In re Application of:
James S. McClain
For: ANTI-THEFT DEVICE FOR BIG
GAME SURVEILLANCE CAMERA
Application no: 10/679,769
Filed: 10/06/2003
Docket no: McClain 3
GAU: 2622
Examiner: Cutler, Albert H.

AMENDMENT UNDER 37 CFR 1.111

Fig. 2

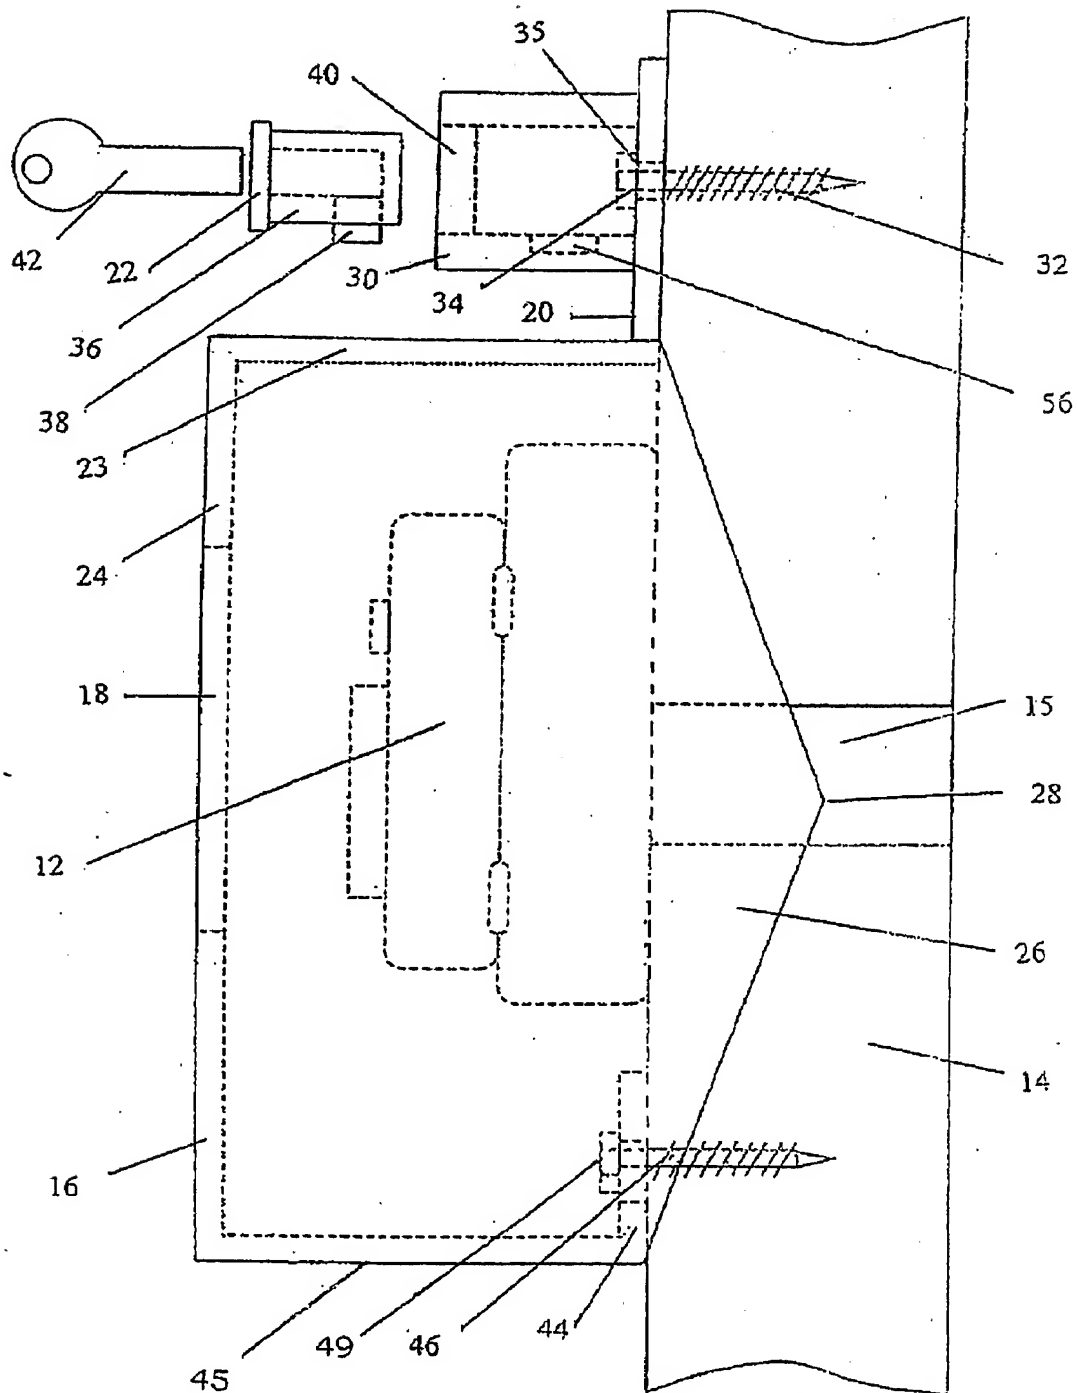
The corrections to Fig. 2 are made on the replacement sheet of drawing of Fig. 2 as required by the Examiner. Here, "bottom 45" and "head 49 of the lag bolt" are respectively labeled.
